## **Addendum No. 2**

Re: Laun Park – Splash Pad Improvements

Project #PR-079-22

Date: July 22, 2024

2 NEW SINGLE LINE RISER DIAGRAM  
NOT TO SCALE

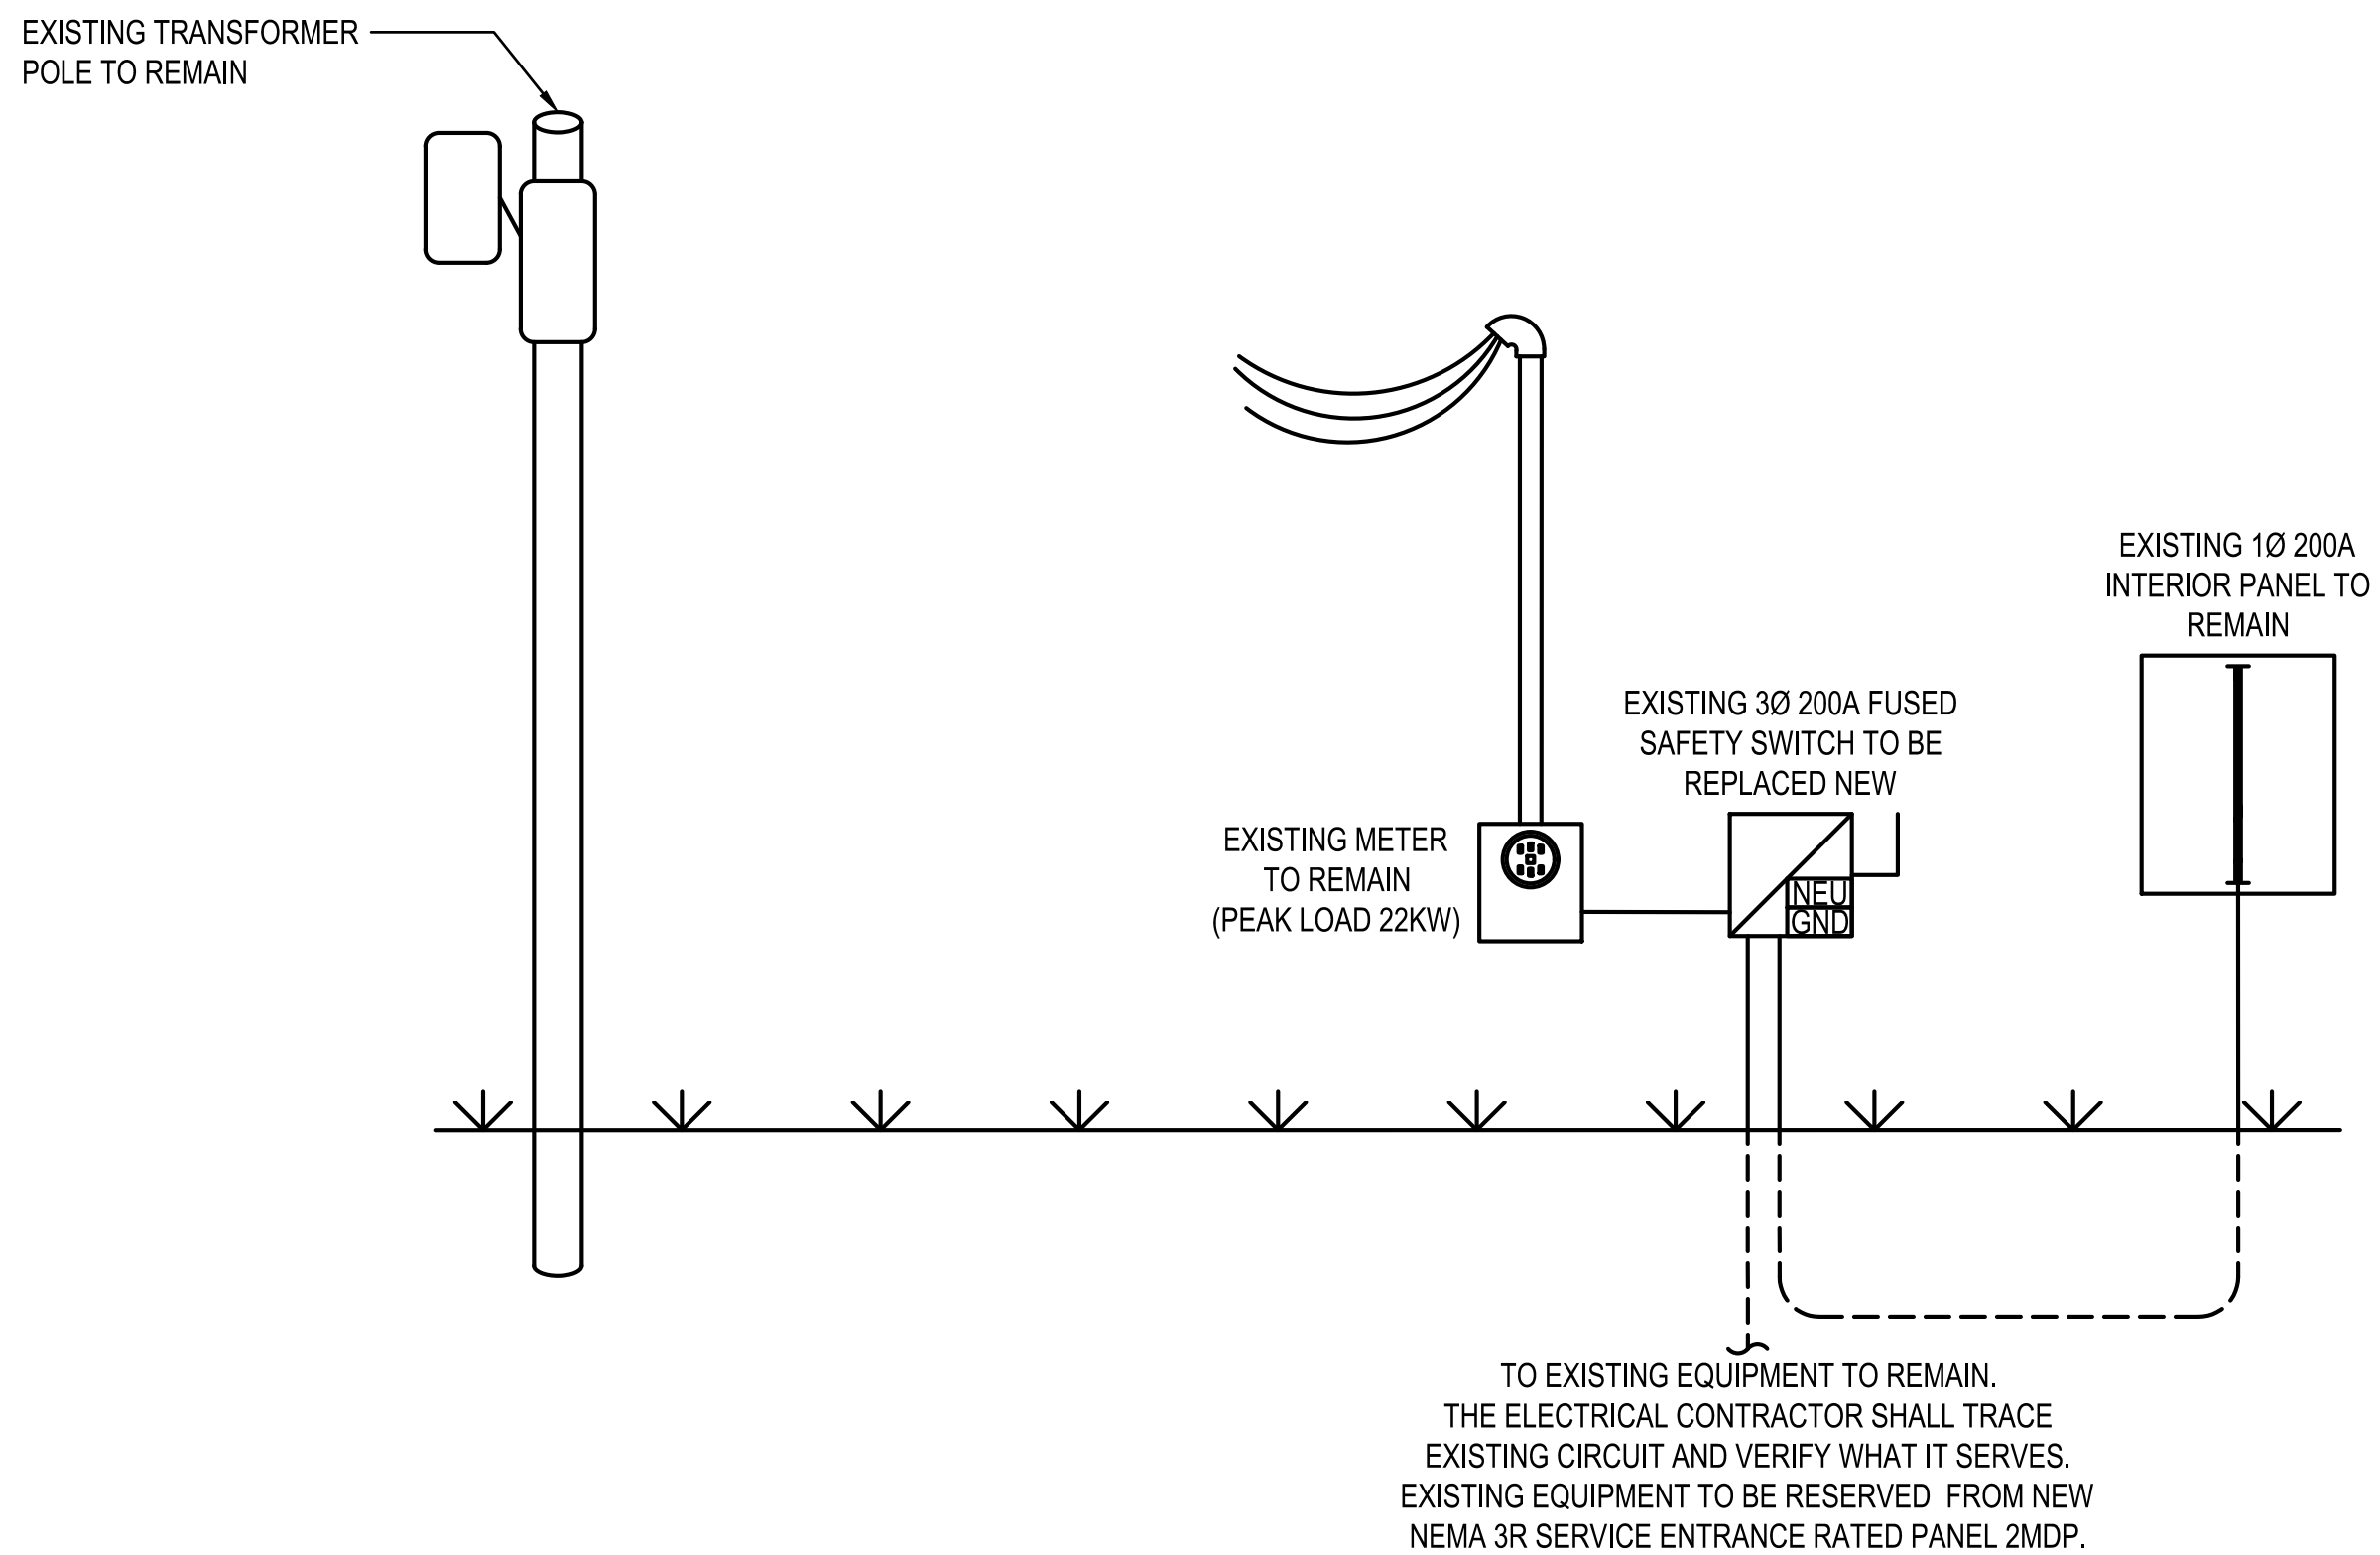
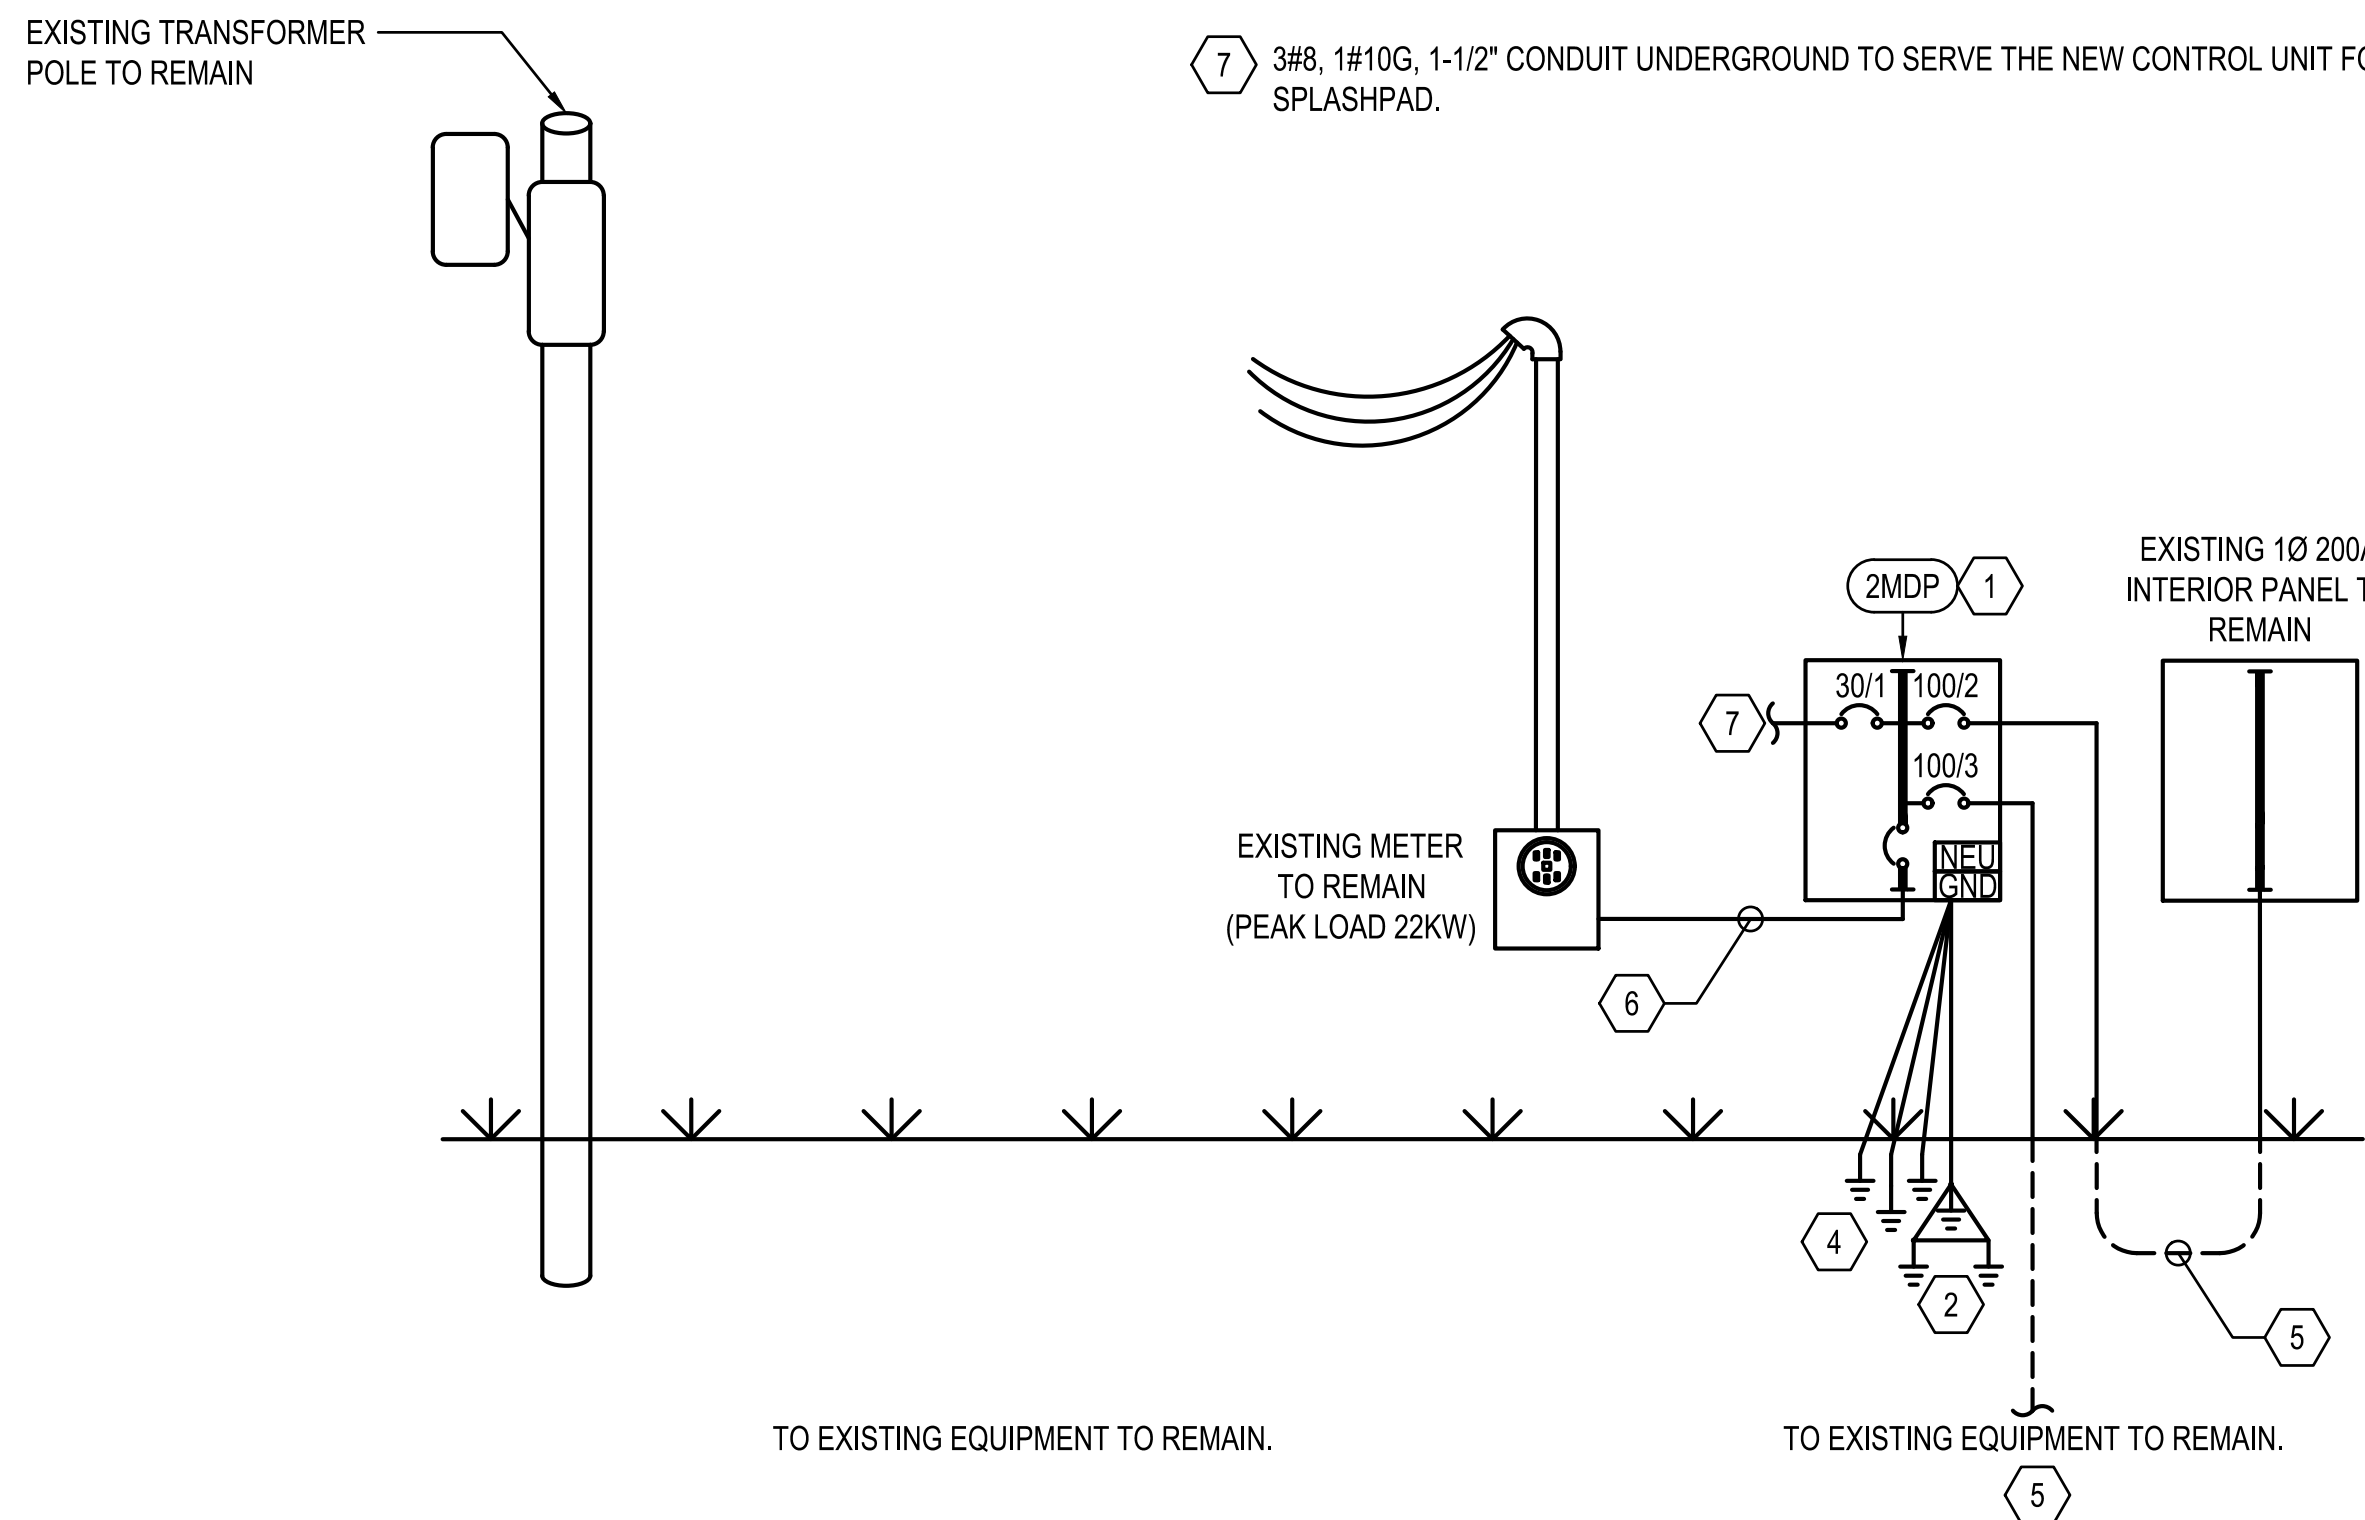
- Item 1. The bid Due Date has been changed to July 31, 2024. All other bidding instructions to remain the same.
- Item 2. Addendum #1 RFI #1 question, “Do you have any requirements on what size and voltage feed is required for the Splashpad controller?”, further clarified in attached drawings, with updates dated July 22, 2024, and should be used to bid electrical portion of project.

- 3#8, 1#10G, 1-1/2" CONDUIT UNDERGROUND TO SERVE THE NEW CONTROL UNIT FOR THE NEW SPLASHPAD.
